18 April 2024
Ref 22255

DA-2023/170
PROPOSED MIXED USE DEVELOPMENT
5-9 GORDON AVENUE, CHATSWOOD
TRAFFIC AND PARKING MATTERS

I refer to Council's letter dated 11 April 2024 to *Mainway Management Pty Ltd*, requesting additional information regarding the abovementioned development proposal (DA-2023/170).

GA Floor Plans
B01 - Carpark

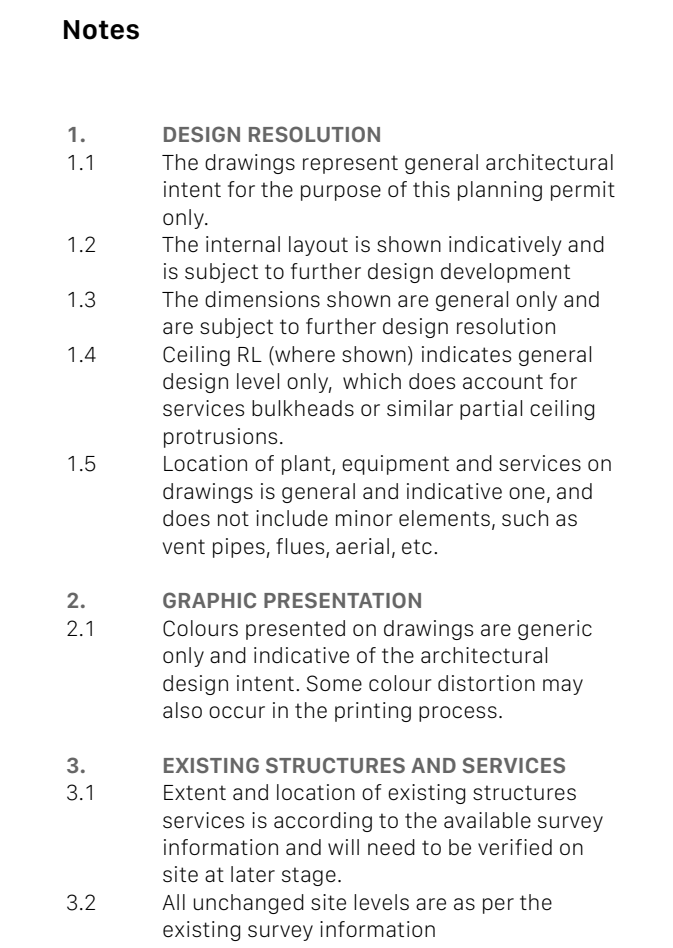
"1. Visitor parking spaces measure as 2.4m wide, with one only 2.3m wide. Visitor spaces are required to comply with the requirements of Class 2 medium term parking and not Class 1 all day / long term parking."

“6. Visitor parking spaces are to comply with the requirements for Class 2 medium term parking, with a minimum width of 2.5m. Dimensions are to be provided to confirm compliance.”

As requested, the visitor parking spaces have been amended to a *minimum* 2.5m wide for 'Class 2 medium term parking', in accordance with the AS/NZS2890.1 requirements.

As requested, and as noted in the foregoing, the visitor parking spaces have been amended to a *minimum* 2.5m wide. Dimensions have also been provided on the revised set of architectural plans.

DRAWING TITLE
 B85 VEHICLE TURNING PATHS - BASEMENT05
 Entering/Exiting Car Space B5-08

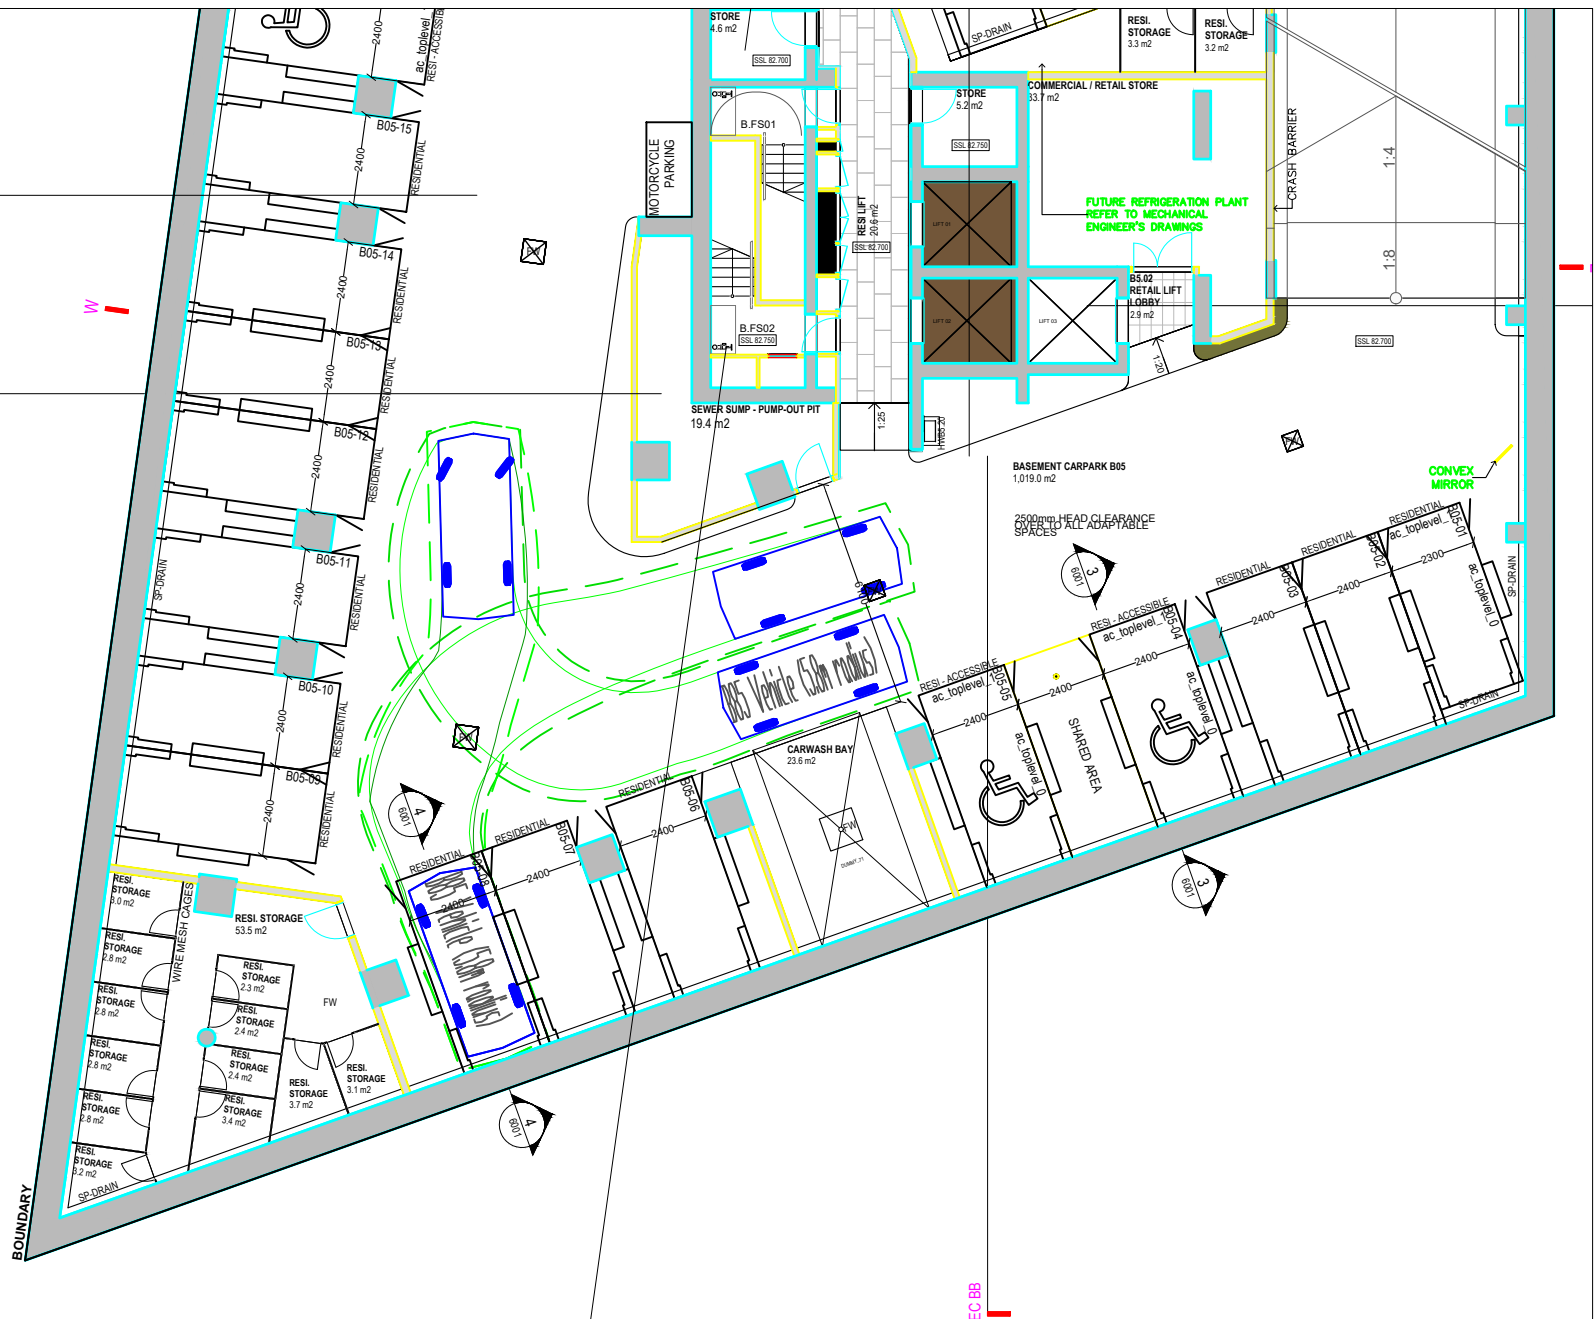
“3. Spaces B02-10, B02-11, B03-10, B03-11, B04-09, B04-10, B05-08 and B05-09 are adjacent to each other and at an acute angle, less than 90degrees. As such, the required aisle width at 90degrees to the spaces is not achieved and it has not been demonstrated that vehicles can access these spaces.”

As requested, a review of the car parking spaces B02-10, B02-11, B03-10, B03-11, B04-09, B04-10, B05-08 and B05-09 have been undertaken. *Swept turning path* diagrams have been prepared using the *Autodesk Vehicle Tracking 2024* program in accordance with the requirements of AS2890.1 confirming that large B85 vehicles can access the proposed parking spaces without difficulty and with sufficient clearances at all times.
